Project: Mankato to Mississippi River Project  
23-157

**Supplemental Information Inquiry 2**

Project: Mankato to Mississippi River Project  
23-157

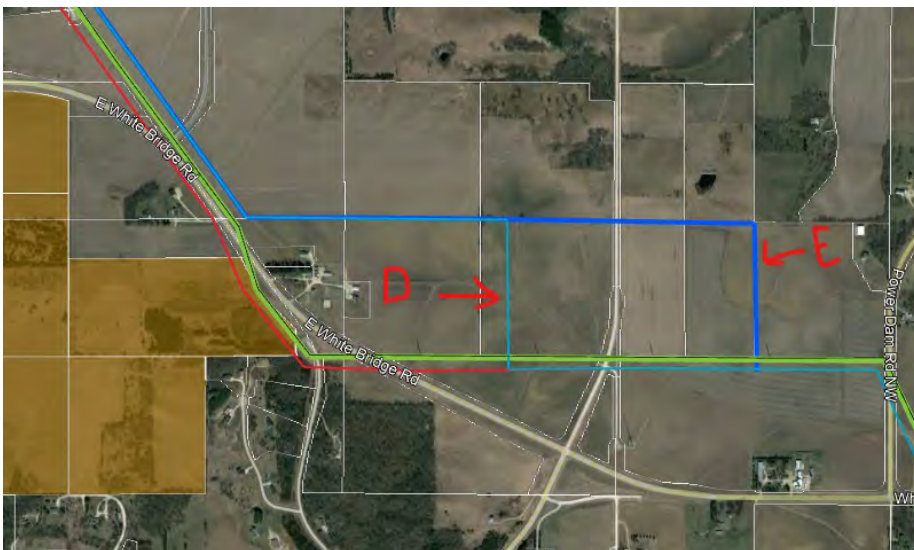
1. This request pertains to Route Segment 9 and Route Segment 18. In a meeting between Xcel and EERA held on 10/02/2024, Xcel noted that should Route Segment 9 be selected by the Commission as part of the final route, the existing line to the west would be reconstructed on the new alignment. Route Segment 9 and Route Segment 18 would replace portions of the applicant-proposed Segment 1 North option, specifically replacing a component of 1F. It is EERA’s understanding that 1F is proposed to be double-circuited with an existing 115 kV line. Based on our meeting, it is our understanding that the existing 115 kV (that 1F would be double-circuited with) would be removed and reconstructed as a double-circuited line with the alternative’s ROW (Route Segment 9 or Route Segment 18’s ROW). In other words, the existing line would be moved further to the east and co-located with Route Segment 9 or Route Segment 18. Please confirm our understanding and that this scenario applies both to Route Segment 9 and Route Segment 18.

That is correct. If either Route Segment 9 or Route Segment 18 are selected the corresponding portion of the existing 115 kV line will be shifted to the new alignment to be double-circuited with the new 345 kV line.

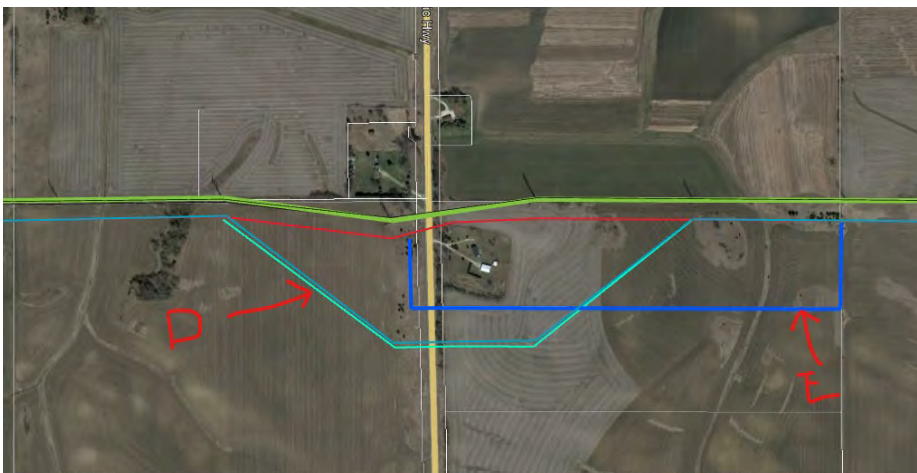
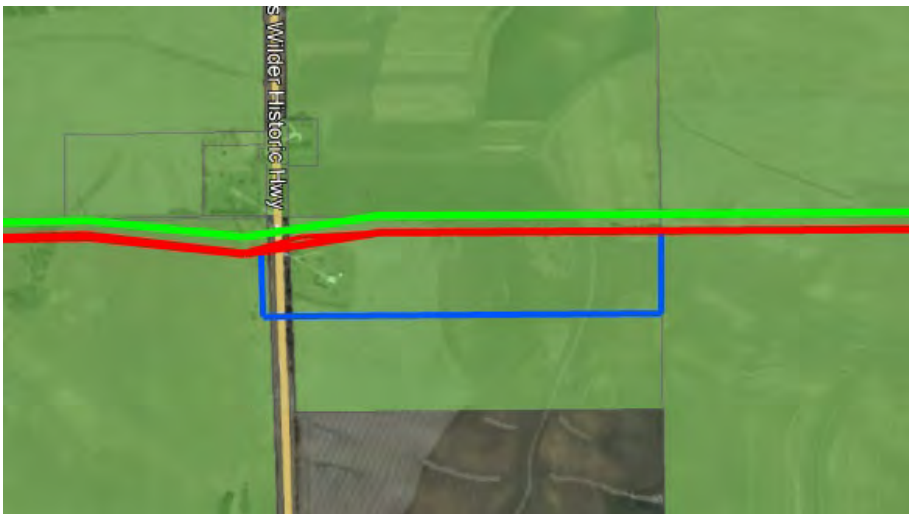
2. This request pertains to Route Segment 12 (CapX Co-Locate). Based on clarification provided by Dale Thomforde via email received on 10/19/2024, the alignment for this alternative was modified to go around Prairie Island Indian Community's property. As discussed in a meeting between Xcel and EERA held on 10/22/2024, this was the original intent in Mr. Thomforde's proposed alternative as outlined in his 7/30/2024 scoping comment. As such, the alignment will be modified to reflect his original described alternative. EERA requested that Xcel propose a wider route width in this area to accommodate Mr. Thomforde's request and to also allow for flexibility should the Commission select this alternative but opt to keep the line parallel the existing line. Xcel provided an updated kmz via email on 10/24/2024. Within this kmz, the requested wider route width was provided and labeled in the kmz as "MMRT\_PUC\_NotificationArea\_20241022." At the southern-most part of the corrected alignment, the route width is shown wider as requested but also extends approximately a half-mile to the east. Please provide an explanation of why the route width extends approximately a half-mile to the east from the alignment.

3. This request pertains to Route Segment 12 (CapX Co-Locate). Based on clarification provided by Dale Thomforde via email received on 10/19/2024, the alignment for this alternative was modified to go south of the property located east of County Highway 63. As discussed in a meeting between Xcel and EERA held on 10/22/2024, this was the original intent in Mr. Thomforde's proposed alternative as outlined in his 7/30/2024 scoping comment. As such, the alignment will be modified to reflect his original described alternative. EERA requested that Xcel propose a wider route width in this area to accommodate Mr. Thomforde's request and to also allow for flexibility should the Commission select this alternative but opt to keep the line parallel the existing line. Xcel provided an updated kmz via email on 10/24/2024. Within this kmz, the requested wider route width was provided and labeled in the kmz as "MMRT\_PUC\_NotificationArea\_20241022." At the eastern end of the corrected alignment, the route width is shown wider as requested but also extends approximately 0.2 mile to the east. Please provide an explanation of why the route width extends approximately 0.2 mile to the east from the alignment.

The route width is extended wider to accommodate a potential alignment that Ellen Heine provided to Dale Thomforde and Rich Davis in an email on 10/18/24, prior to receiving Dale's update/correction, as shown in the first screenshot below. Dale responded to that email with a change in what Ellen had provided. Note, his proposed alignment cuts through the middle of a parcel (see second screenshot below, options labeled D for Dale and E for Ellen). Xcel Energy's understanding was that Rich felt that we should include both options when developing the route width. If that understanding was incorrect the route can be adjusted to be narrower in this area.

Similar answer as to question 2 above: The route width is extended wider to accommodate a potential alignment that Ellen Heine provided to Dale Thomforde and Rich Davis in an email on 10/18/24, prior to receiving Dale's update/correction, as shown in the first screenshot below. Dale responded to that email with a change in what Ellen had provided. Dale's proposed alignment does not follow parcel lines (see second screenshot below, options labeled D for Dale and E for Ellen). Our understanding was that Rich felt that we should include both options when developing the route width. If that understanding was incorrect the route can be adjusted in this area.

**Figure 1**

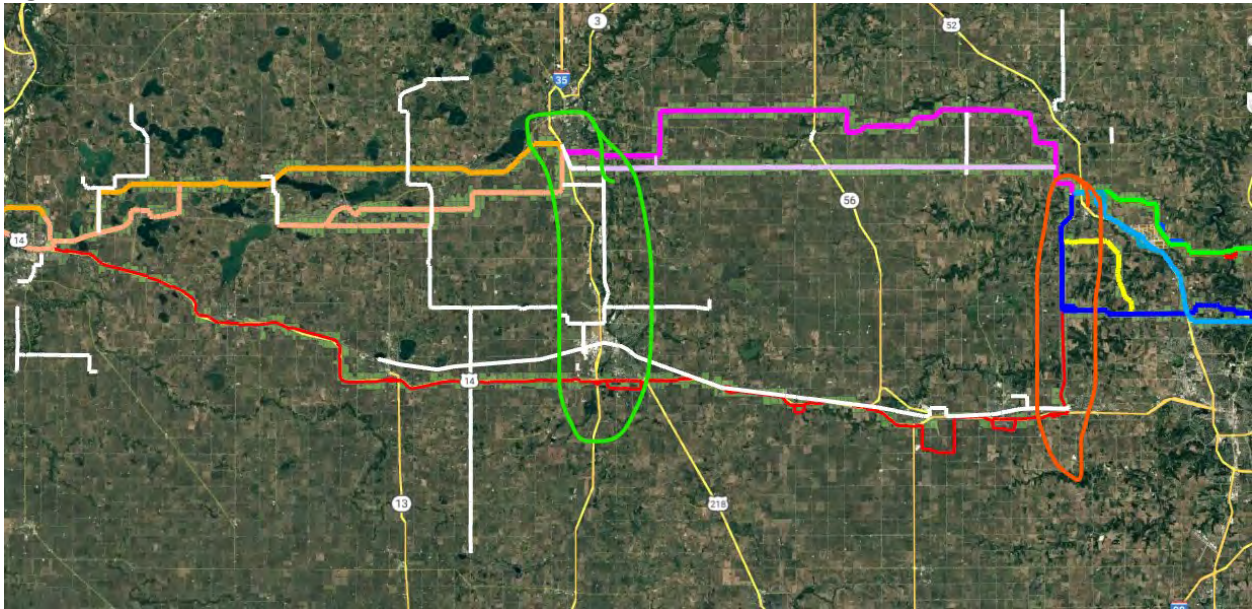
4. This request pertains to Route Segment 17 (Hwy 14 option). Xcel's August 28, 2024 letter responding to scoping comments noted the potential future need to connect to the West Faribault Substation. This was also noted in Xcel's route permit application (Section 2.7 Design Options to Accommodate Future Expansion). The potential connection of the project's 345 kV transmission line to the substation would serve the future purpose of connecting the lower voltage transmission system to the backbone (345 kV) transmission system. Your email dated 10/18/2024 to EERA reiterated: "The proposed alignments in our application did not connect at the West Faribault Substation, but routed close to it, based on the expectation that in the next several years it will be necessary to connect that sub to the 345 kV system. We are doing some more research to try to clarify when that would be needed, and what the alternative would be if the 345 isn't close (possible other system upgrades, etc.) but wanted to note that a Hwy 14 alignment may necessitate a future, additional 15ish mile 345 kV line (green circle in the screenshot below for approximate location) to connect to West Faribault." The screenshot provided by Xcel is shown below as Figure 1. Please provide an estimated construction timeline that Xcel would anticipate that the connection to the West Faribault Substation could be required and any updates on the potential for the 15-mile new transmission line and its necessity.

A construction schedule is not available at this time as the exact timing for when there will be a need to connect the 345 kV system to the West Faribault Substation is not known at this time. However, we expect there will be a need to connect the 345 kV system to the West Faribault Substation in 10-15 years. The exact timing of the need for this connection will depend on potential generation retirements and the development of new renewable generation in this area.

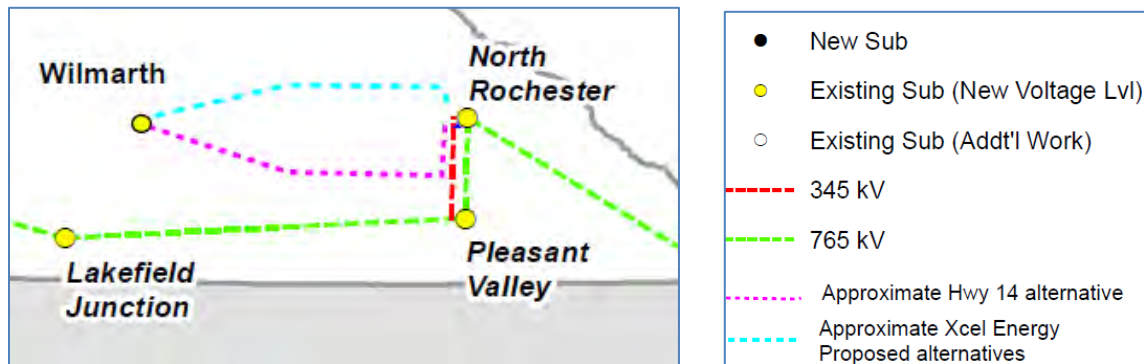
5. This request pertains to Route Segment 17 (Hwy 14 option). Xcel's August 28, 2024 letter responding to scoping comments states: "In addition, the Highway 14 would also require a new approximately 13-mile long 345 kV connection from the Byron Substation to the North Rochester Substation. There is already a 345 kV transmission line between these two substations such that this new 345 kV line could be double-circuited with the existing line. However, this area of the system is expected to require an additional 345 kV connection from the Byron Substation to the North Rochester Substation in the future and double-circuiting with this existing 345 kV line at this time would make this future 345 kV connection more difficult." Your email dated 10/18/2024 to EERA reiterated this point and circled the area in question in orange in Figure 1 above. For inclusion in the EIS, please provide addition detail of what would make the future 345 kV connection "more difficult." Please also provide an estimated construction timeline that Xcel would anticipate that the additional 345 kV line could be required.

The MISO Tranche 2.1 portfolio is expected to be approved in December 2024. That portfolio includes a new 345 kV transmission line from Pleasant Valley to North Rochester with an in-service date of 2032 (as well as a new 765 kV line from Lakefield Junction to Pleasant Valley to North Rochester to Columbia (in Madison, WI)). See screenshot below and the link to MISO's web site.

The Pleasant Valley to North Rochester project follows an existing 345 kV transmission line (line #0979) and assumes rebuilding that line to a double-circuit 345/345 kV line. If the Highway 14 alignment is selected for the MMRT Project the Byron to North Rochester portion of that option would involve double-circuiting with the existing line 0979. This would mean that it is no longer possible to double-circuit that portion of the upcoming LRTP Tranche 2.1 Pleasant Valley to North Rochester line with the existing line, as that position will be taken. This will necessitate finding a new route for the LRTP 2 Tranche 2.1 345 kV line. We have attempted to illustrate with some edits to the MISO map as shown below (note this does not show existing lines such as the existing Pleasant Valley to North Rochester 345 kV line).

Figure 2

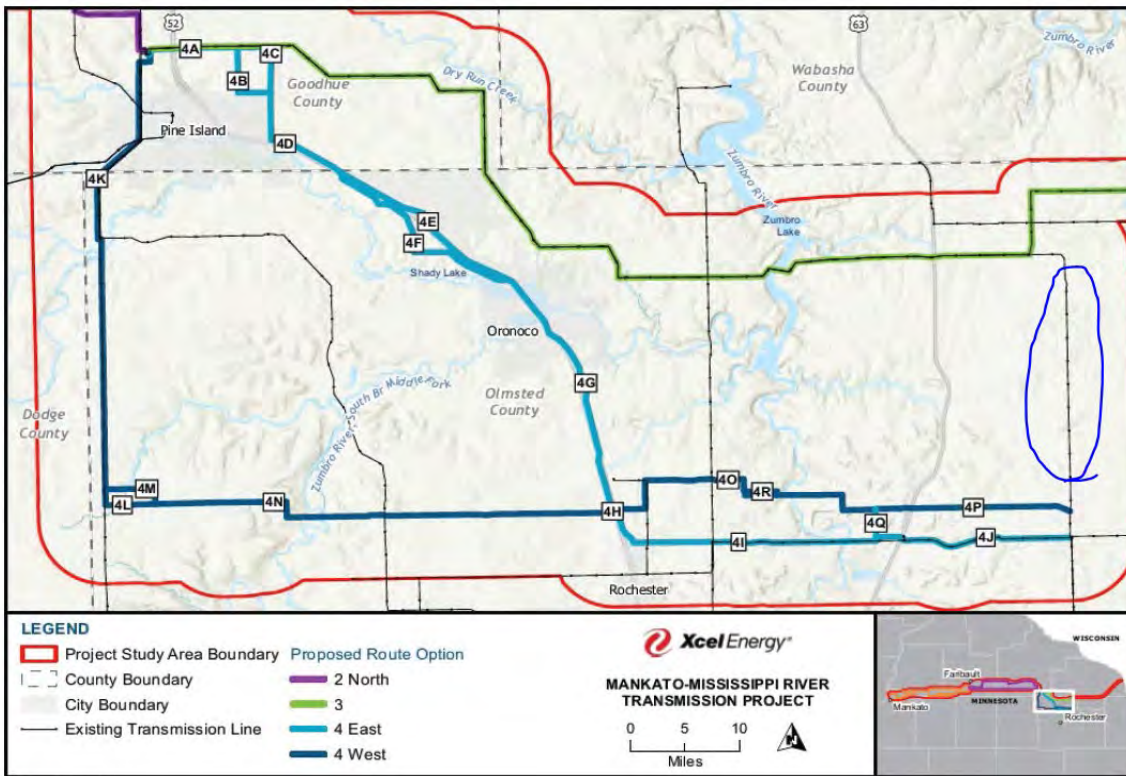
9. If Proposed Route Option 4 East or 4 West were selected, please confirm if the portion of the existing 161 kV line circled in blue Figure 2 would be removed or remain in place.

The status of this segment needs further investigation by the applicants to confirm future intent.
